## 2.5.4 Stability of Subsurface Materials and Foundations

**Figure 2.5.4-9 - Allowable Bearing Capacity of Typical Foundations  
(Reproduced from SSAR Figure 2.5.4-13)**

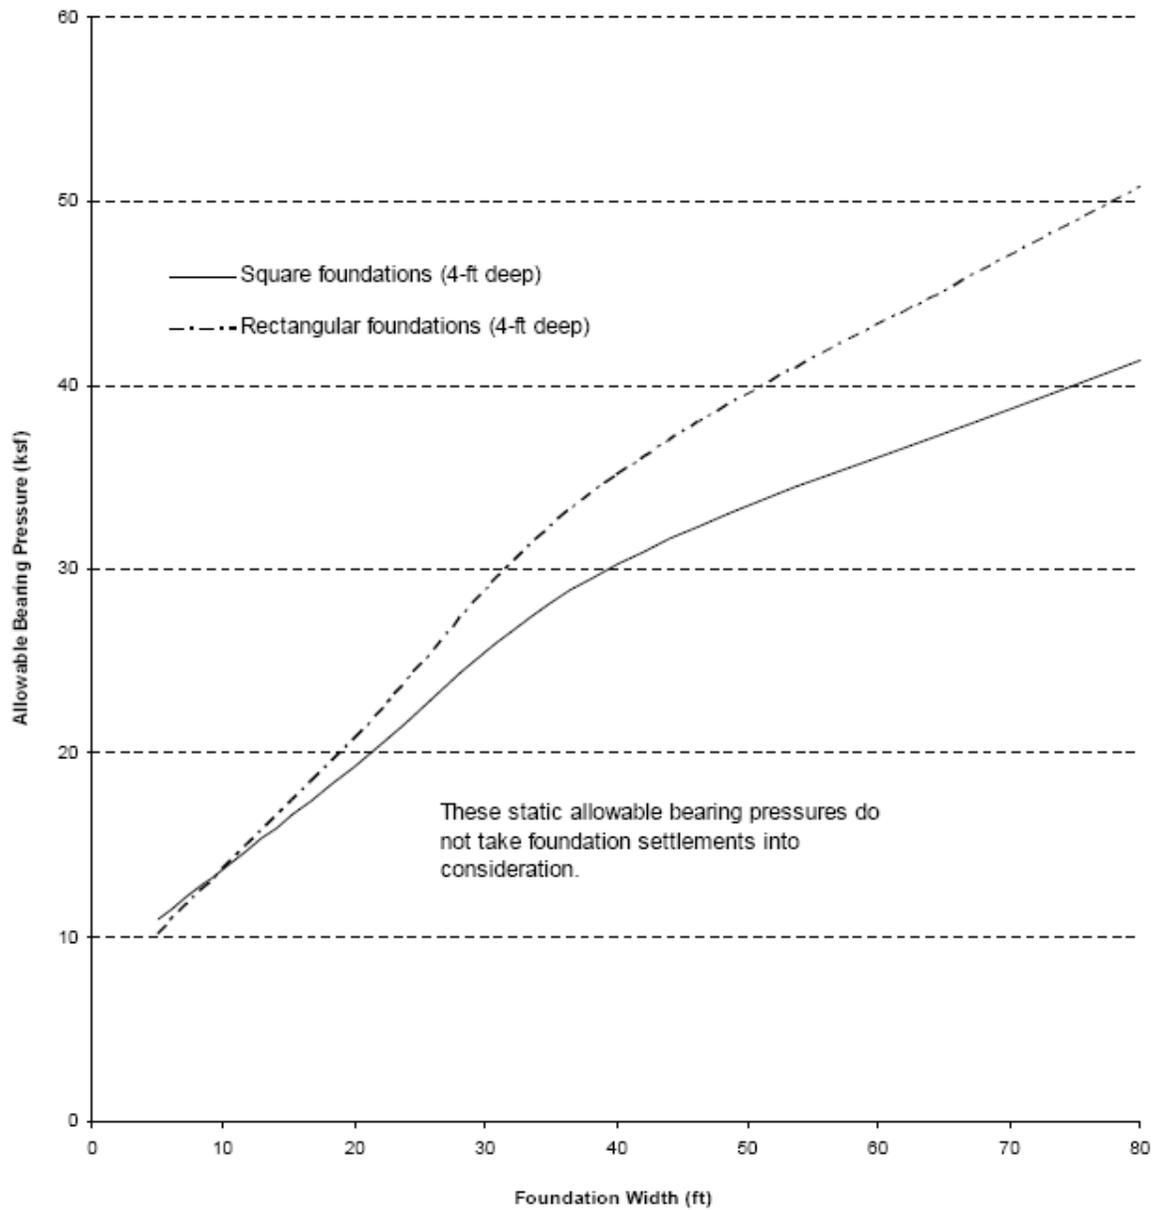
In RAI 2.5.4-18, the staff asked the applicant to provide detailed information on its determination of the allowable bearing capacity value. In its response, the applicant provided a detailed description of bearing capacity evaluations based on the Vesic (1975) formula. In addition, the applicant later clarified that the calculated value was net allowable bearing capacity, not the gross bearing capacity; therefore, the formula used in the actual calculation was slightly different from that presented in the reference. From its review of the applicant's response, the staff considers that the Vesic (1975) formula is based on primary assumptions of gross shear failure of soils under the foundation. Although this allowable bearing capacity formulation is applicable for general foundation analysis, it is inappropriate to use it in nuclear power plant foundation design. The control factors of allowable contact pressure for a large and heavy structure typically are not general shear failure but are (1) settlements; (2) allowable pressures used in design of the wall/basemat intersection; and (3) toe pressures developed during potential overturning and sliding of the facility. Based on the above considerations, the staff concludes that the allowable bearing capacity value provided by the applicant is not appropriate when considering the expected governing issues controlling the site evaluation. This is **Open Item 2.5-22**.

**Figure 2.5.4-10 - Settlement of Typical Foundation  
(Reproduced from SSAR Figure 2.5.4-14)**

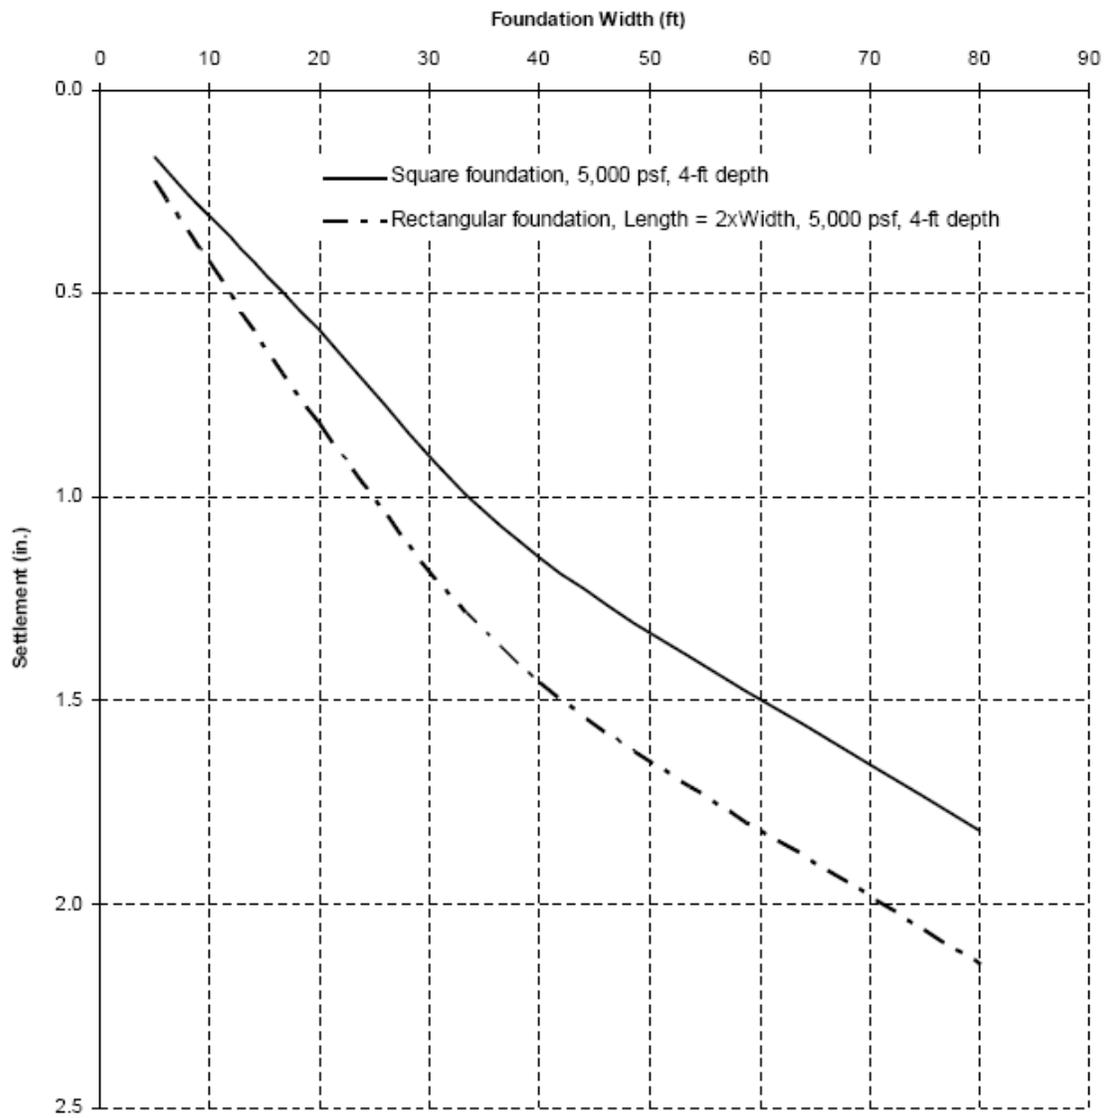
1. A primary concern of potential total and differential settlements is how these settlements compare with what the design of the reactor takes into consideration. It is important to compare the estimated settlements, which are appropriate for evaluation of the acceptability of the site at the ESP stage, with those incorporated into the plant design to evaluate the degree of conservatism because there will be severe impact to the safety of the SSCs once unexpected differential settlements occur.
2. The contact pressures associated with the planned reactor model are of interest and need to be considered at the ESP stage to estimate potential settlement. Since the data for a given reactor facility are available, the applicant should incorporate it into the site evaluation.
